Ridge View Estates, Preliminary Plan No. 120080150

Staff Report Date: October 28, 2011

Preliminary Plan No. 120080150: Ridge View Estates with a Preliminary/Final Water Quality Plan

Staff Recommendation: *Approval with conditions.*

Figure 3 – Preliminary Plan

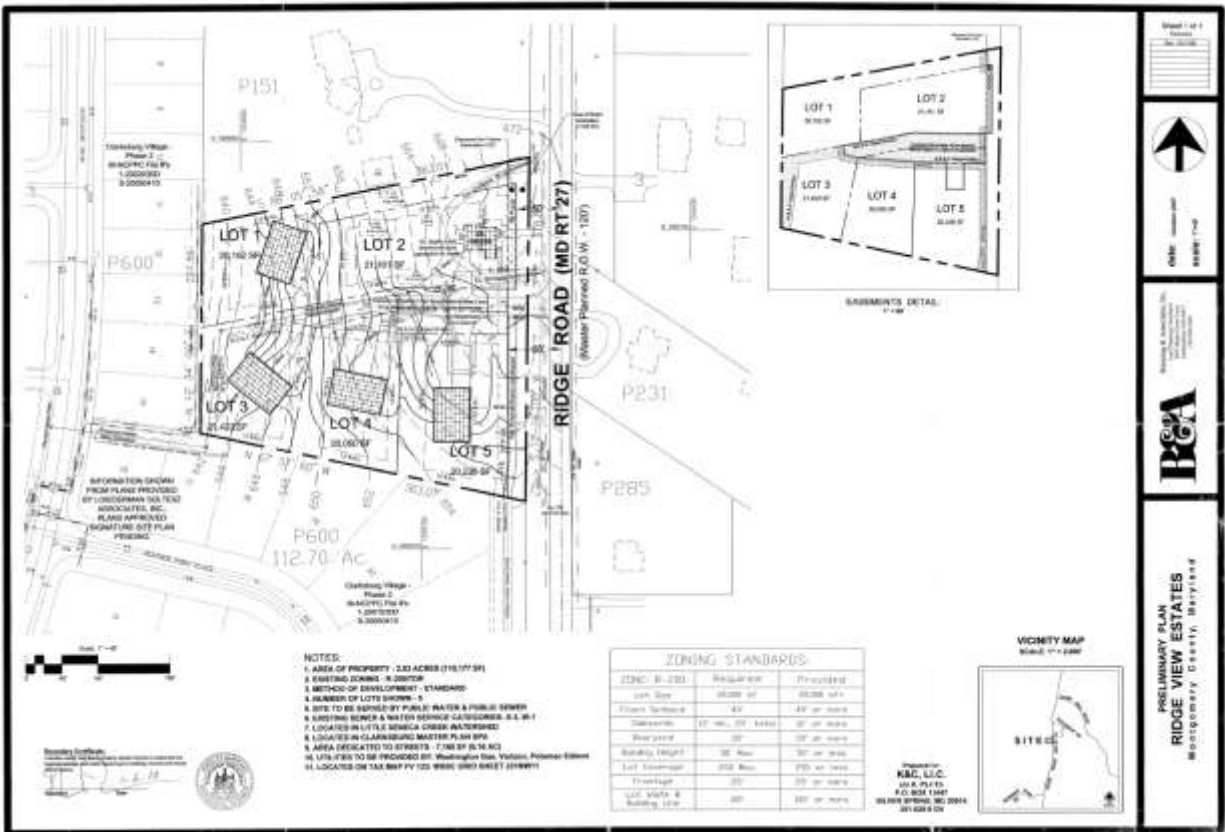
The application proposes to subdivide the 2.53 acre parcel into five lots; one for the existing house and four lots for new, one-family residences. All five lots will share a new private driveway out to Ridge Road. All lots will have frontage on Ridge Road; three will be pipestem, or flag lots, two will be conventional rectangular lots. Public water lines will be extended from an existing water main in Ridge Road, while public sewer will be extended from the Clarksburg Village subdivision through an easement established for this property.

The preliminary plan drawing shows the required dedication for Ridge Road, 60 feet from the existing centerline of the highway, except for a small section in front of the existing house that is shown as an easement for future dedication. This section cannot be dedicated at this time because it would make the house non-conforming with the R-200 front setback standards of 40 feet. At such a time that the right-of-way is needed, the easement will be conveyed to the State. As a public taking, the house and lot are afforded certain exemptions under Chapter 50 and will remain as a grandfathered, non-conformance with zoning setbacks. An eight foot wide shared use path will also be constructed along the Ridge Road frontage. This path will connect to the shared use path that is to be built by the developers of Clarksburg Village abutting the property to the south. This preliminary plan is in substantial conformance with the 1994 Clarksburg Master Plan.

- 5) The applicant must dedicate all road rights-of-way as shown on the approved preliminary plan.
- 6) The applicant must construct an eight foot wide shared use bikepath along the property frontage within the Ridge Road right-of-way as shown on the preliminary plan drawing. The shared use path must be completed commensurate with the completion of the new driveway access apron as required by the Maryland, State Highway Administration (MDSHA).

Figure 3a – Preliminary Plan Lots

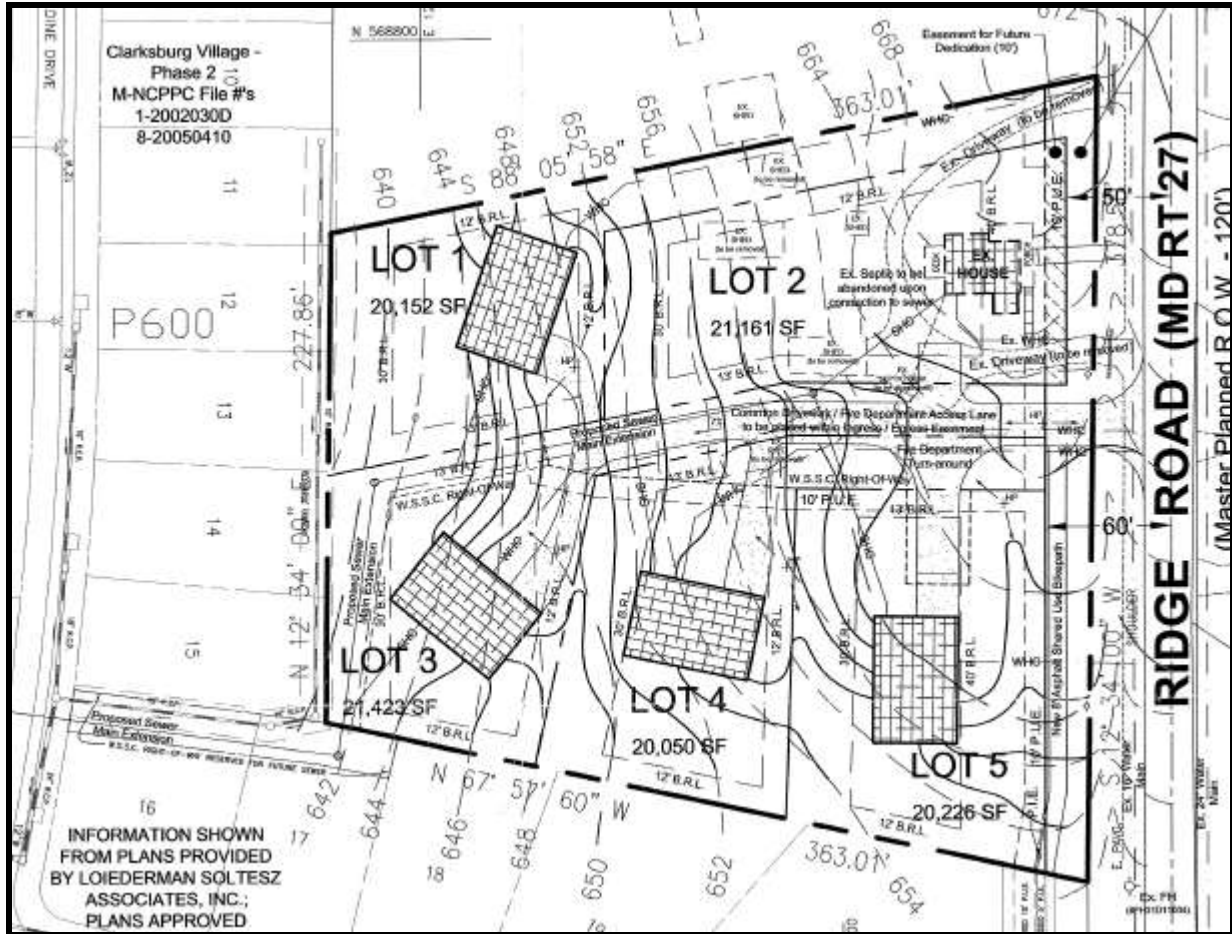
The location of tree ST-1 (30 inch White Oak) is within the buildable area of proposed lot 1. The siting of any house on this lot and the associated grading for the house will impact the critical root zone of this tree. Because of setback restrictions, there is no option that would eliminate damage to the root zone. In addition, significant impacts to approximately 25% of this tree's roots will result from the construction of the required sewer main extension that is necessary for the whole development. Sewer is not available along Ridge Road and is designed to come from the west through a WSSC easement to be established by record plat in the Clarksburg Village subdivision. The sewer is then extended on to the subject property, down the centrally located driveway, to serve all five homes. Because the sewer must be aligned within this off-site and on-site easement, it is not possible to avoid impacts to the root zone of this particular tree.

Tree ST-6, (32 inch Chestnut Oak) is located very close to the front porch of the existing house. While it is not to be physically removed as part of this development and will likely remain for a considerable time, the tree is within the master plan right-of-way from Ridge Road and it is in a public utility easement (PUE) required by local utility providers. Because of these conflicts, the long term survival of this tree cannot be assured through easements. The result is that tree ST-6 can be cleared at any time by the homeowner or utility companies who might need the PUE, and it is not feasible to provide extraordinary measures to further protect or save the tree.

The two specimen trees to be shown as not saved by this plan are ST-1 and ST-6 ST -1. The property affords few opportunities to mitigate these impacts, therefore, consistent with the County Arborist; staff is recommending no mitigation for the two variance trees proposed to be removed.
